MEETING TITLE: Update to FAA on Columbia River Crossing Project

DATE: Tuesday, May 8, 2007 @ 1 pm

FAA EXHIBIT – PEARSON AIRSPACE
REPLACEMENT BRIDGE MID-LEVEL

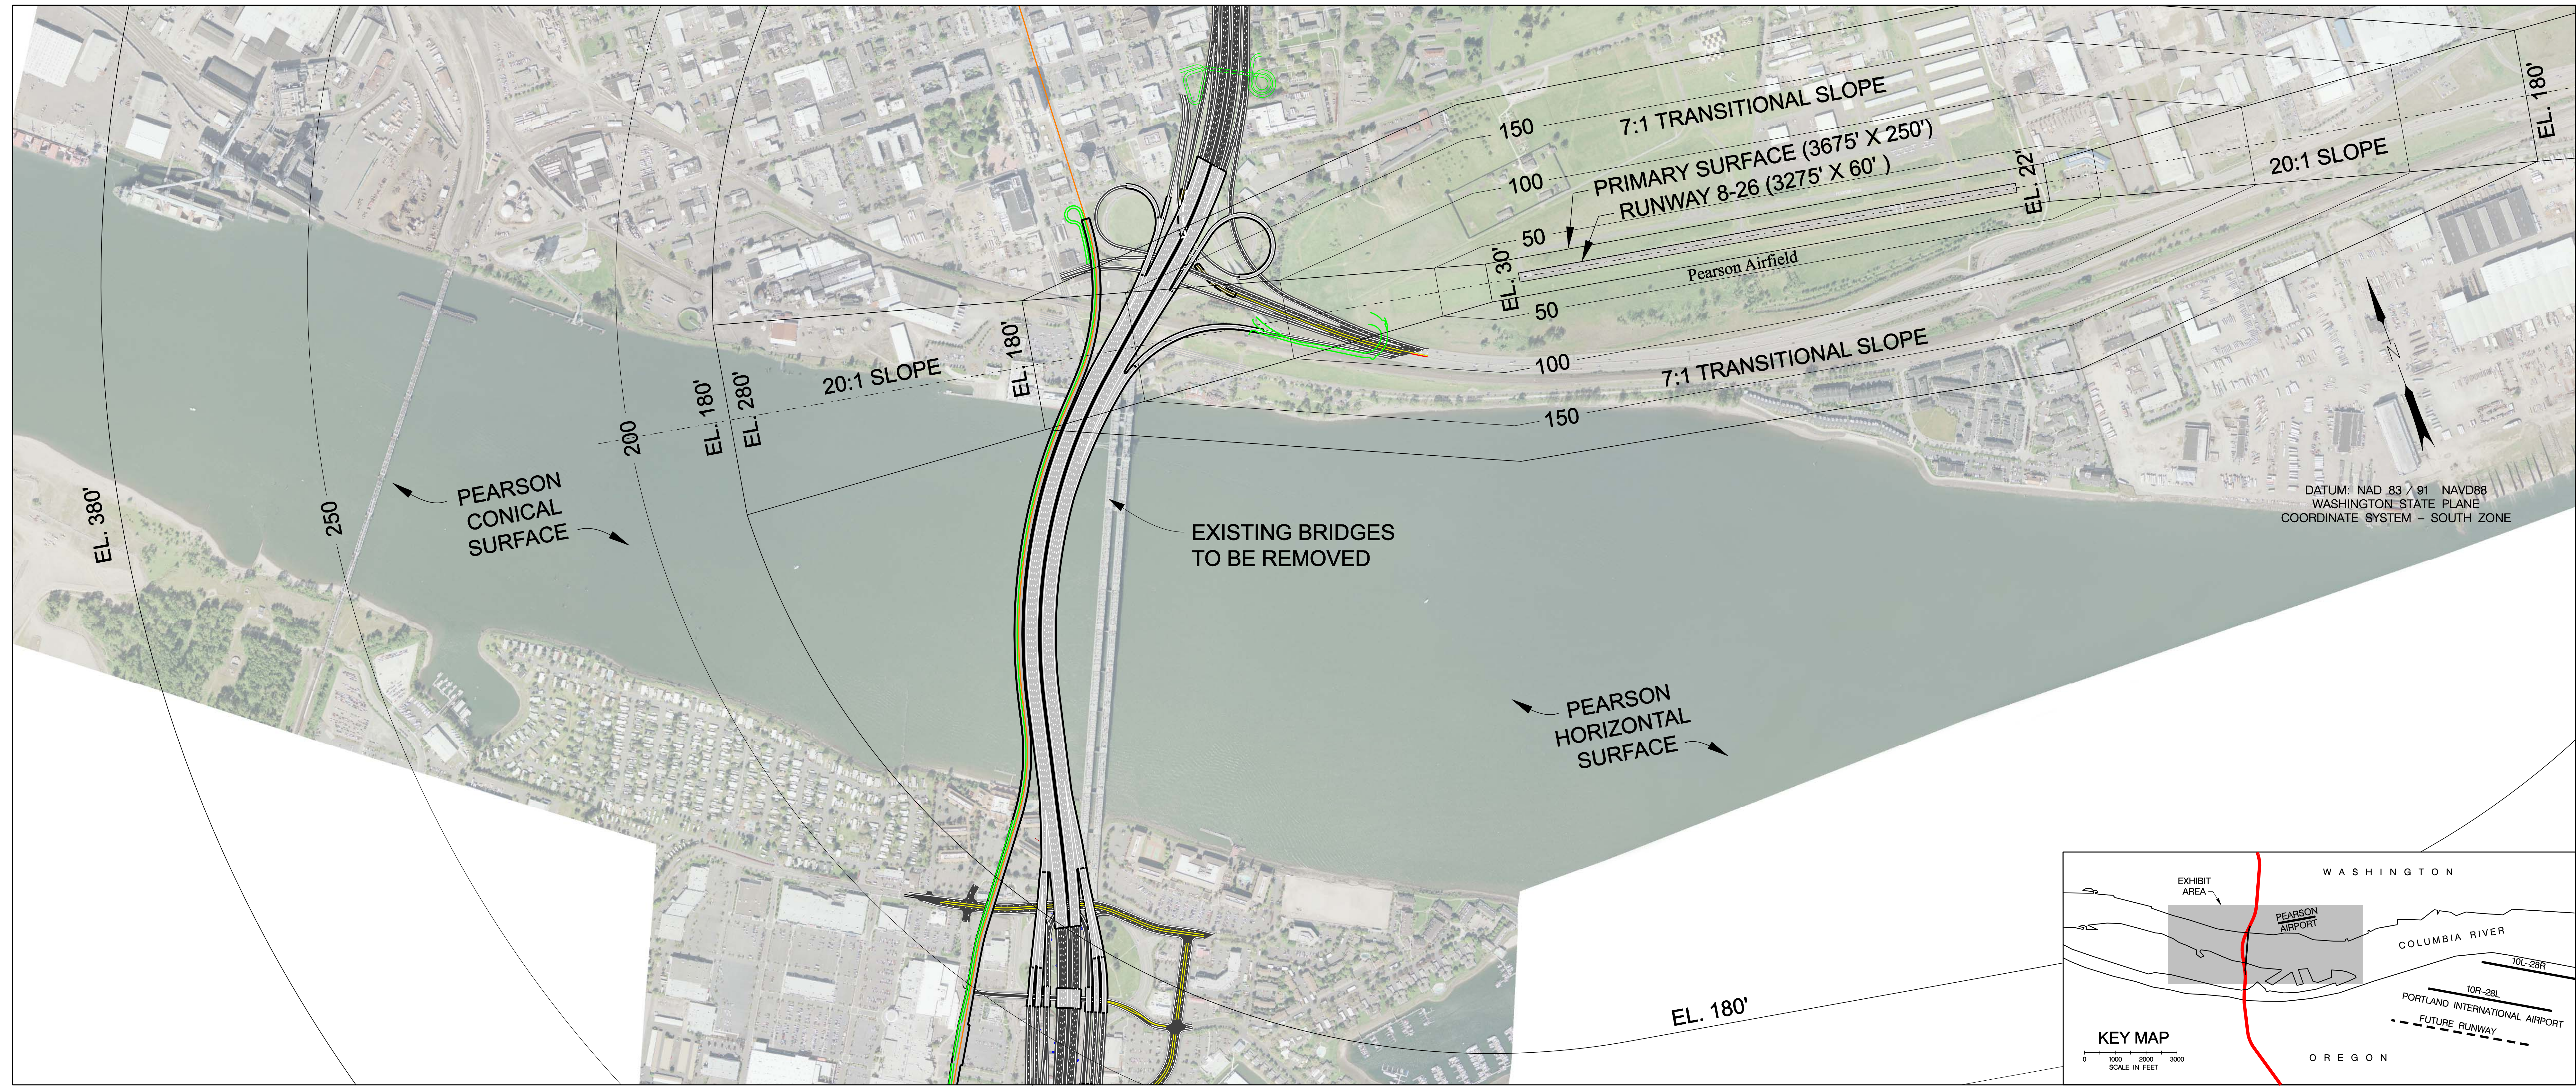
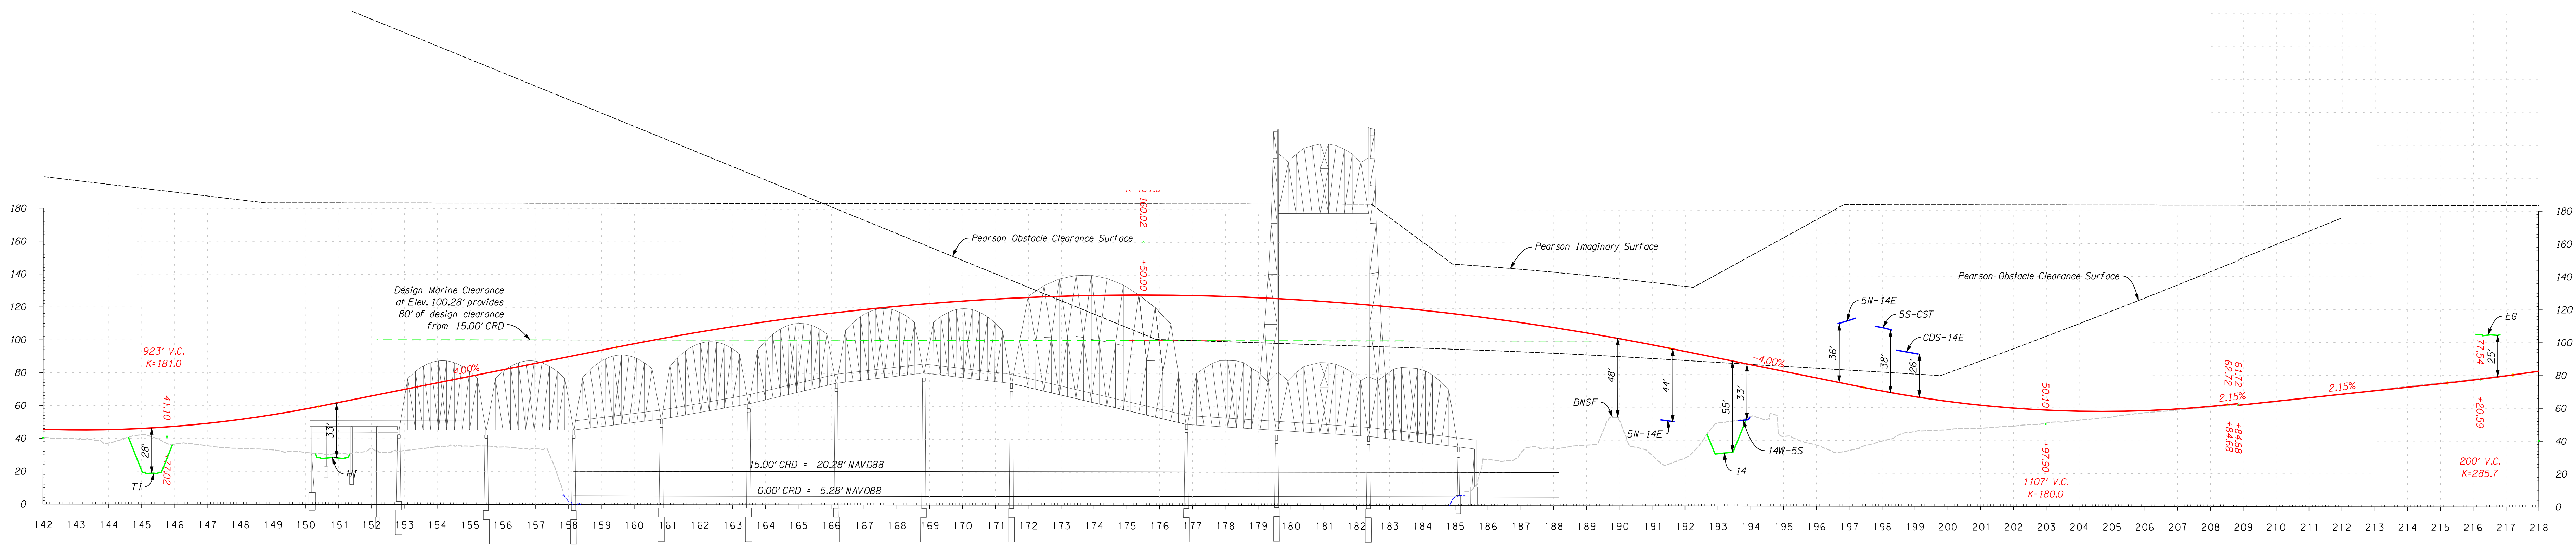
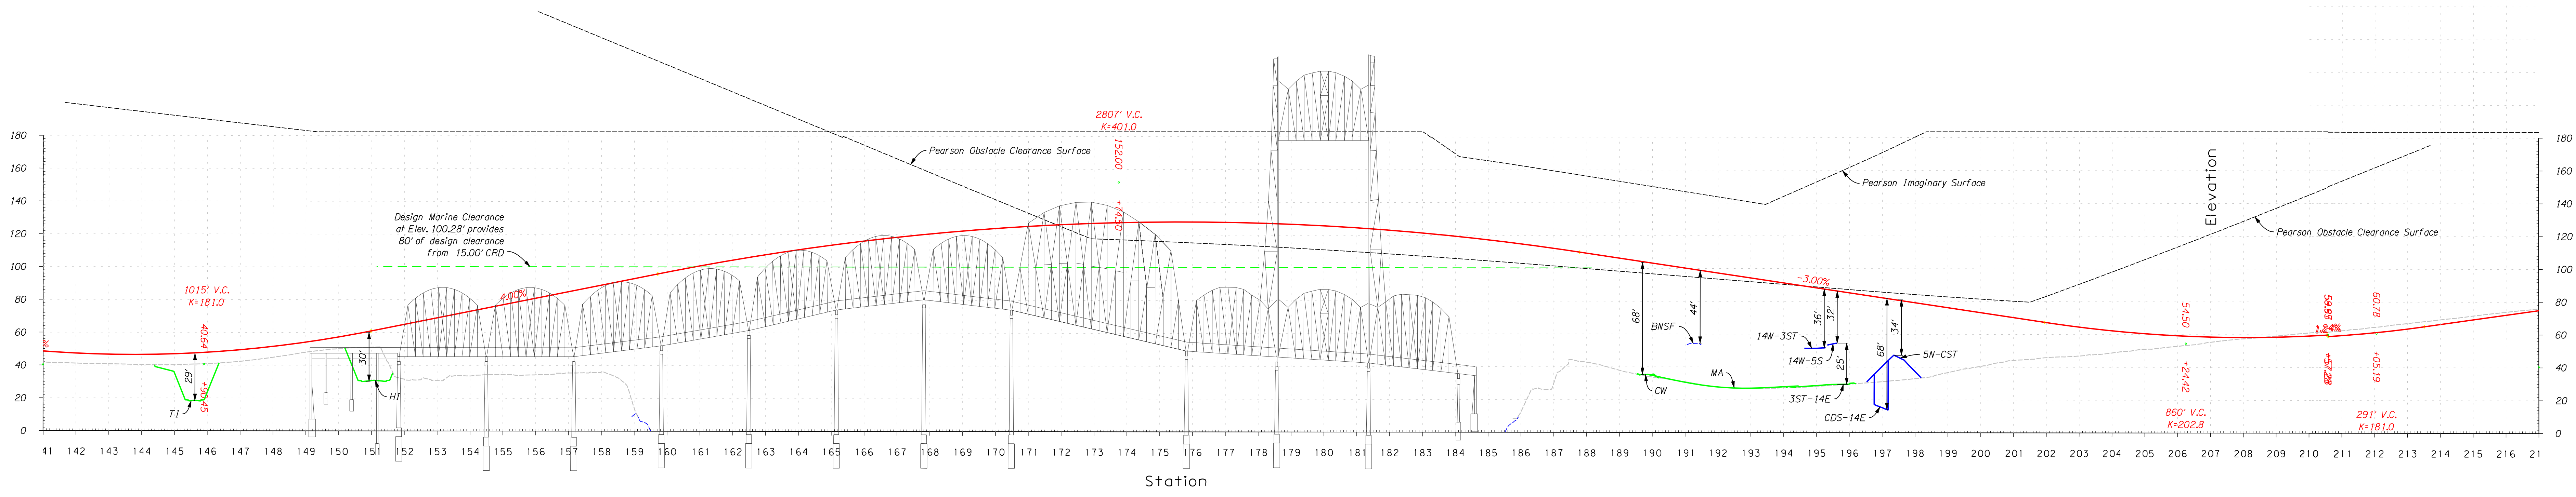
- Questions were passed on through the UDAG group on “how high can the structure go?” Comments from FAA were consistent with previous comments:
 - FAA will not answer how high. Submit the proposal and they will analyze and comment.

- If they analyze and the comments are “no impact”, then that is acceptable.
 - Implied that towers not structural are not looked positively upon by FAA. Possibly need lights, and/or painted red or white. Concerned with safety.

- Poles spaced far apart are better than poles spaced close together which makes a wall effect. Higher probability to hit them.
 - Prefer open space – the more open the better above deck.

- FAA doesn’t look favorably on decorative structures in airspace. (Safety.)
 - PDX 62.5:1 clears existing towers.
 - It is upto the community to decide transportation mode, not FAA. If the solution is not safe for aircrafts taking off and landing at Pearson, this may impact Pearson service. If “objection”, may also impact liability of structure owner.

- Project needs to consider crane heights during construction.
